RFP Addendum No. 01

DATE ISSUED: January 25, 2026
TO: Invited Bidders
FROM OWNER'S REPRESENTATIVE: Collin Frink
Plante Moran Realpoint
3000 Town Center, Suite 100
Southfield, MI 48075
ON BEHALF OF CLIENT: Livonia Public Schools (LPS)
SUBJECT: Addendum for LPS Pool Filtration – Franklin & Churchill High
Schools

ADDENDUM

Addendum No:	001
Project:	Livonia Public Schools FHS & CHS Filtration Projects Livonia, MI
Project No:	2025-042
Owner:	Livonia Public Schools
Documents Issued:	January 6, 2026
Addendum Issued:	January 23, 2026

POOL MECHANICAL ROOM DEMOLITION PLAN (LEVEL BELOW)

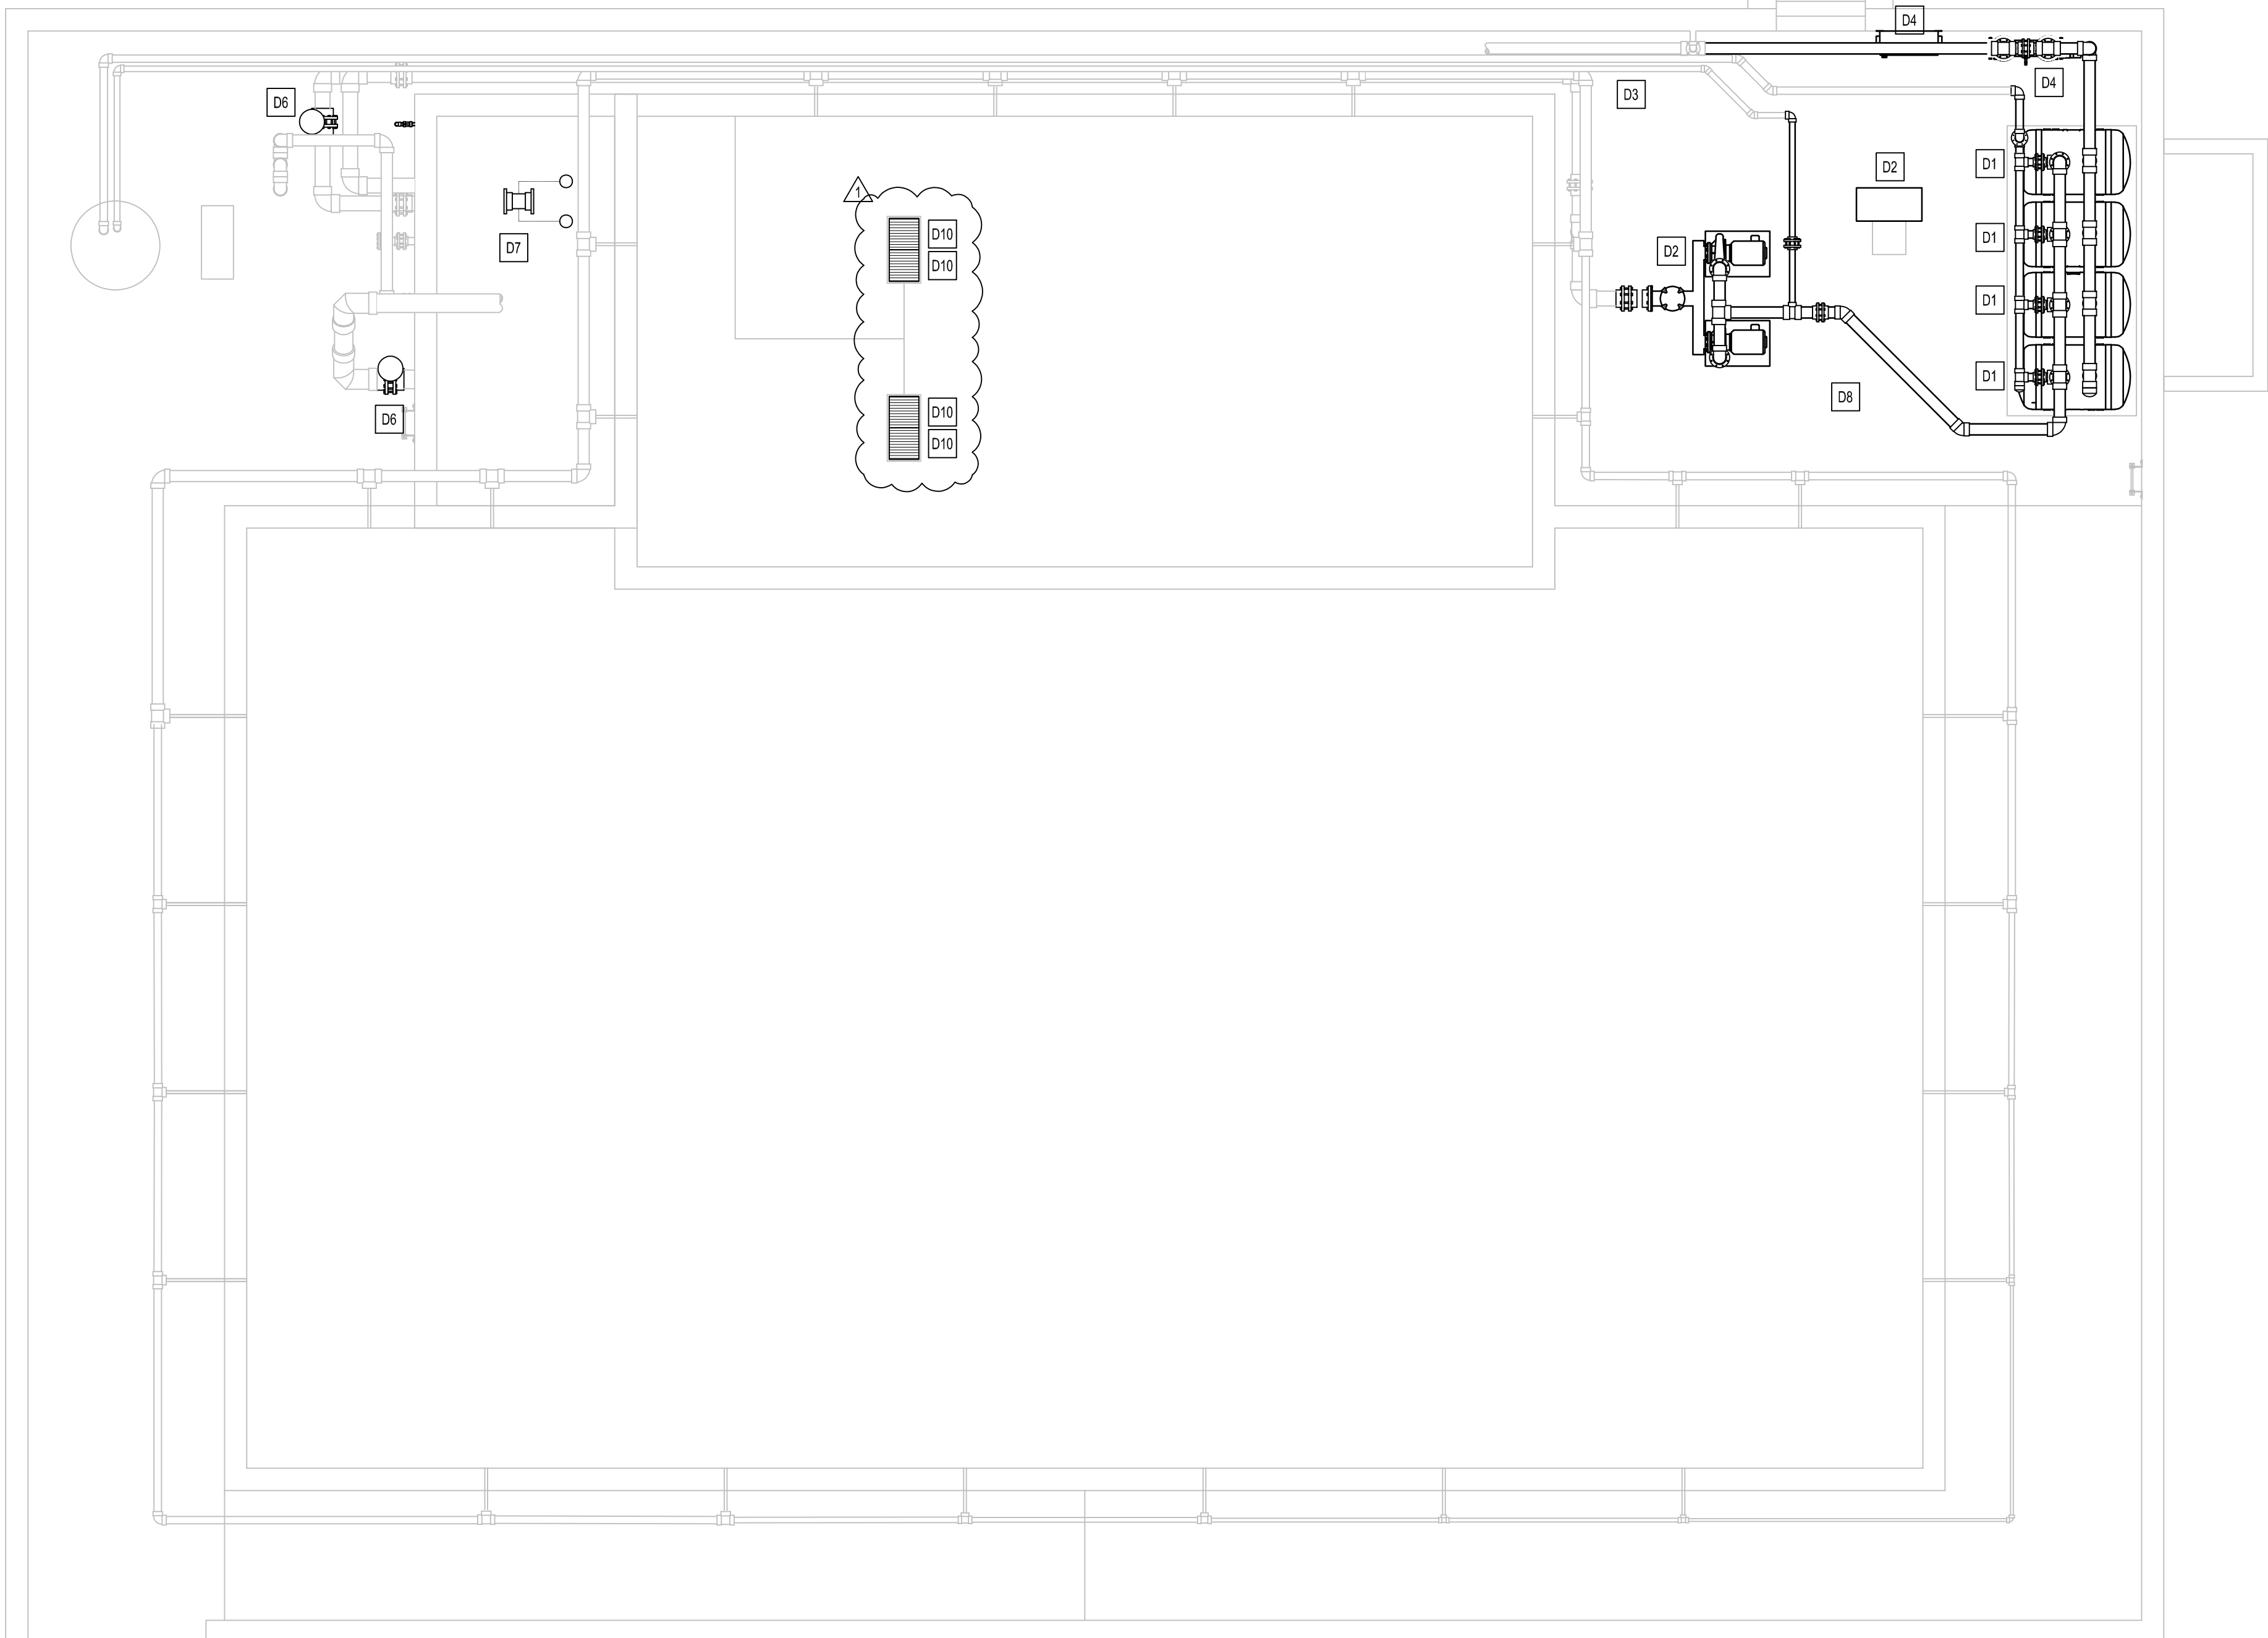
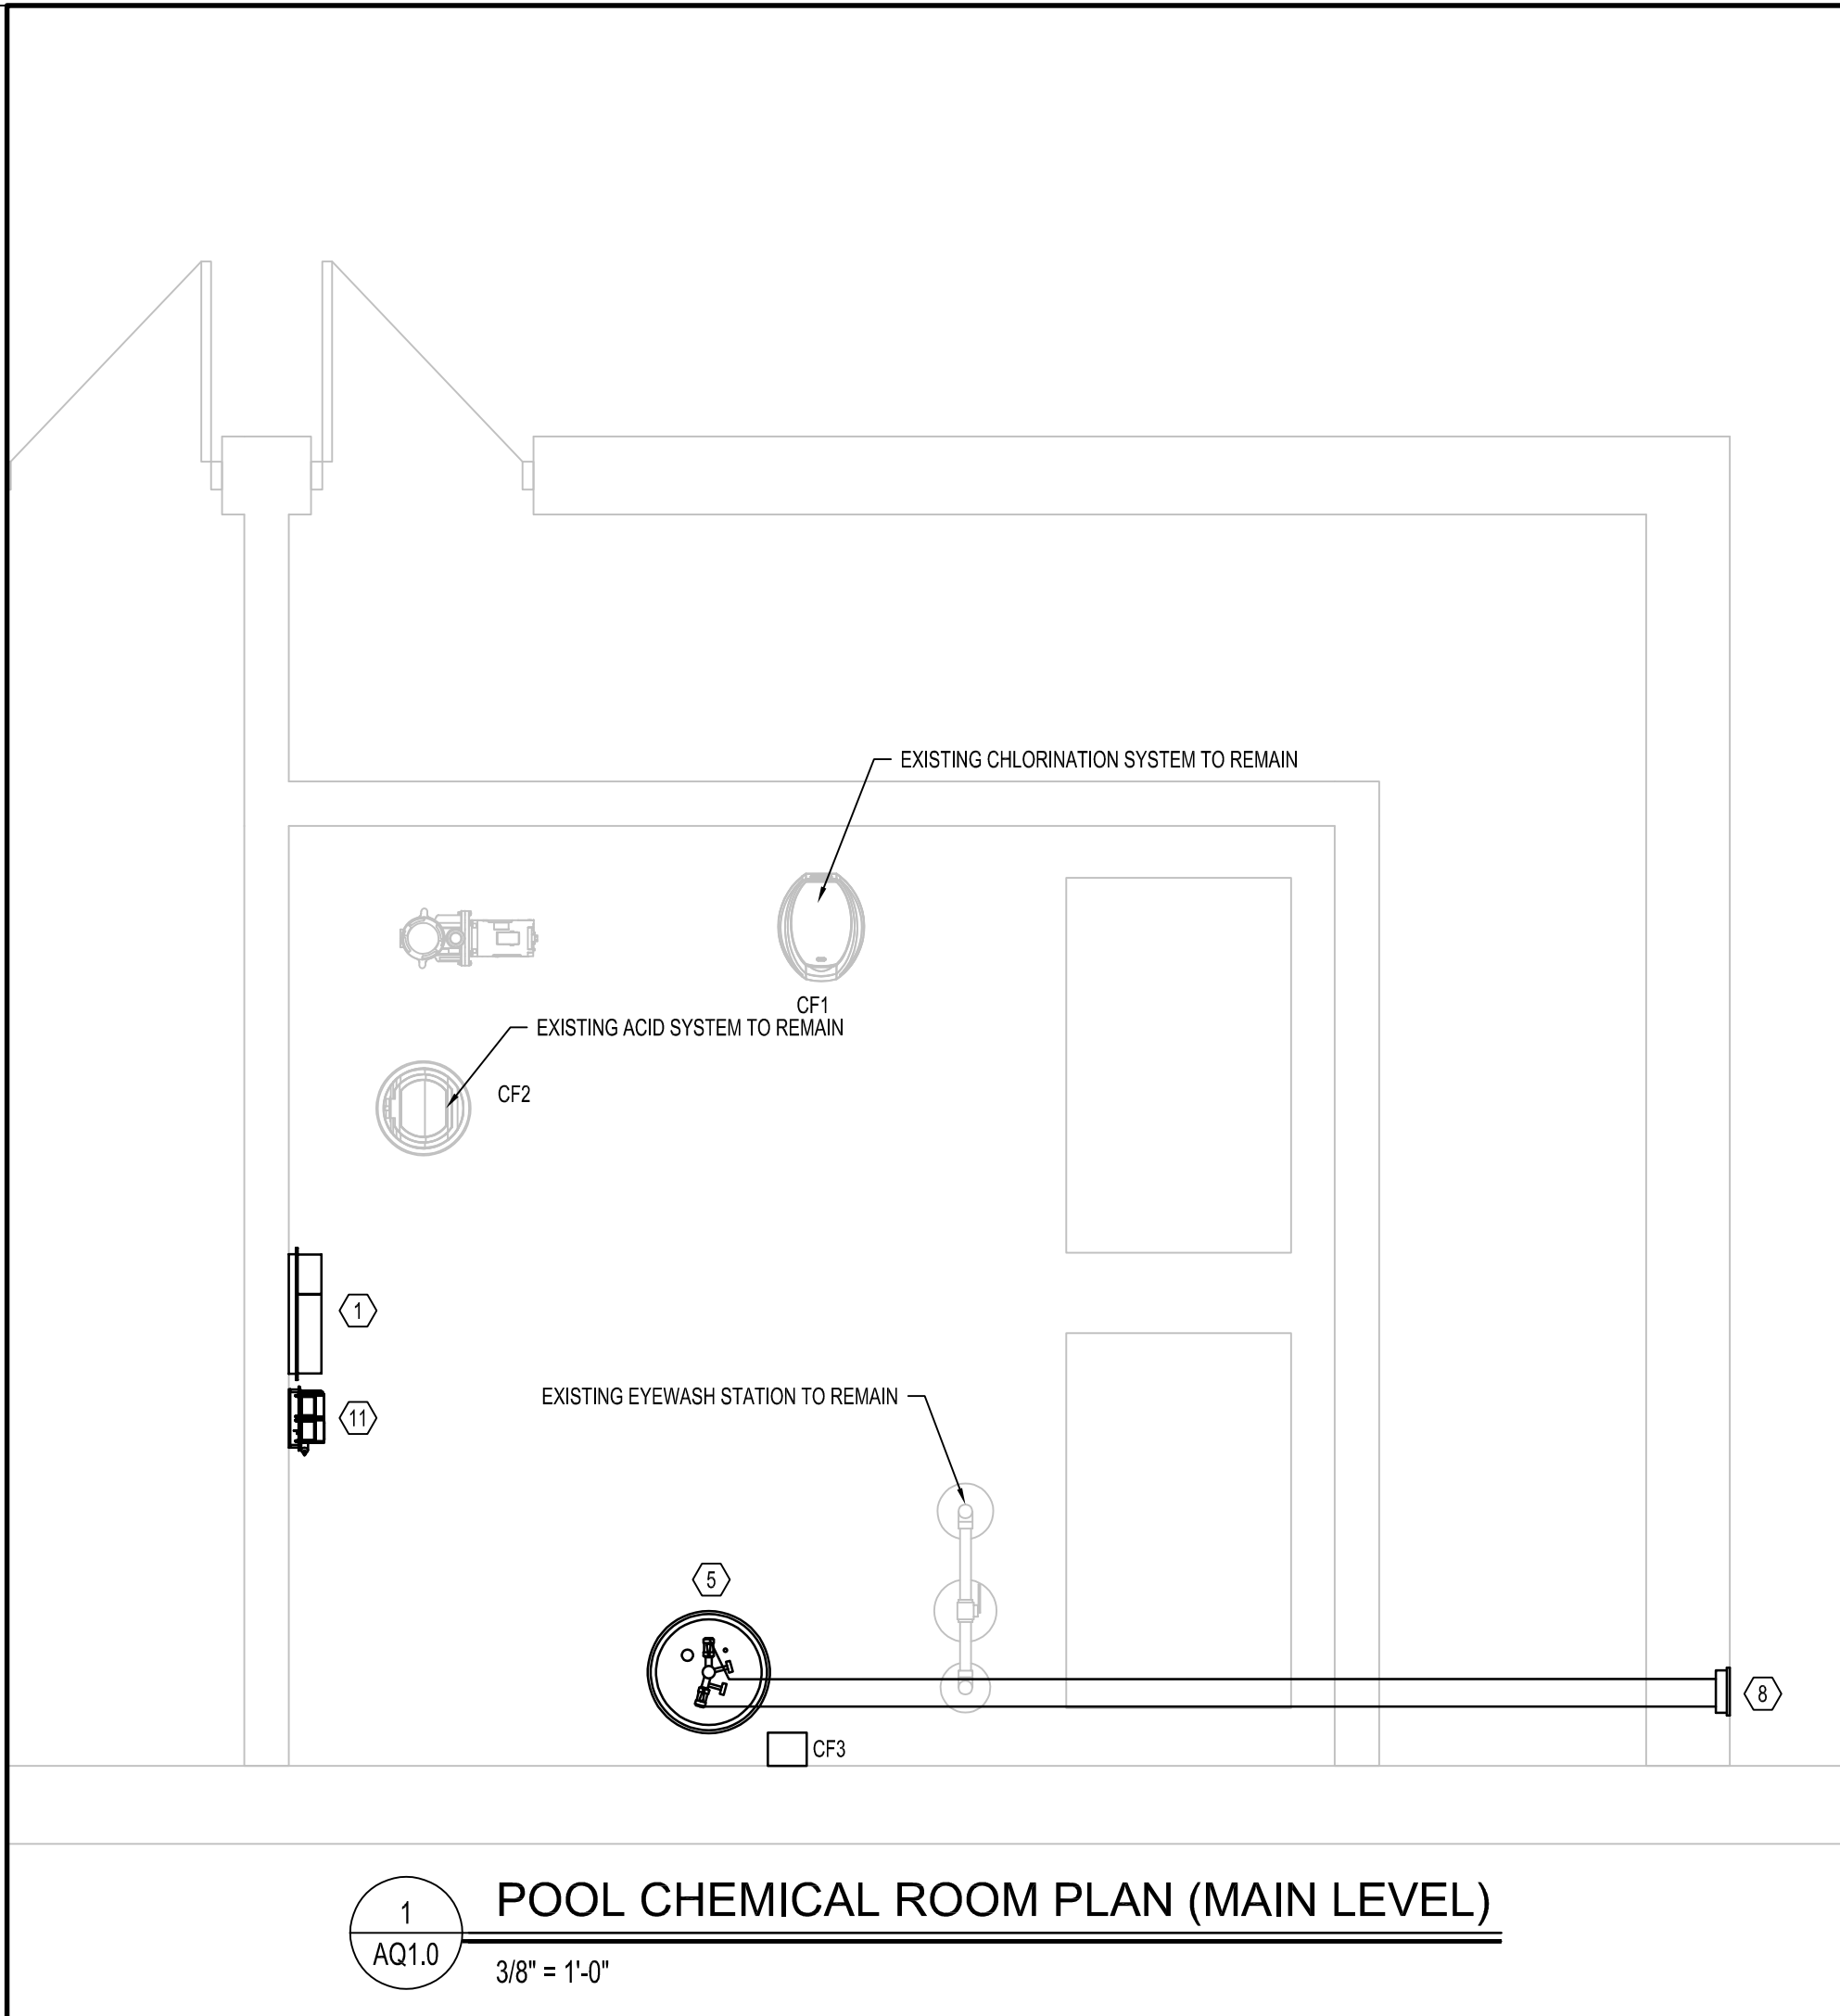
- 1. Refer to Sheet AQ0.0 – Pool Reference Plan (issued):**
 - a. Main Drain Schedule added to sheet.
 - b. Main Drain M1 tagged on plan.
- 2. Refer to Sheet AQ0.1 – Pool Demolition Plan (issued):**
 - a. Demolition note D10 added to plan and note block indicating removal of VGB covers.
- 3. Refer to Sheet AQ1.0 – Pool Renovation Plan (issued):**
 - b. Note added to plan indicating new main drain covers.

- 10. Remove existing variable frequency drive panel.
 - 11. Remove existing VGB covers at main drain sumps.
 - 12. Dispose of demolished items and materials promptly.
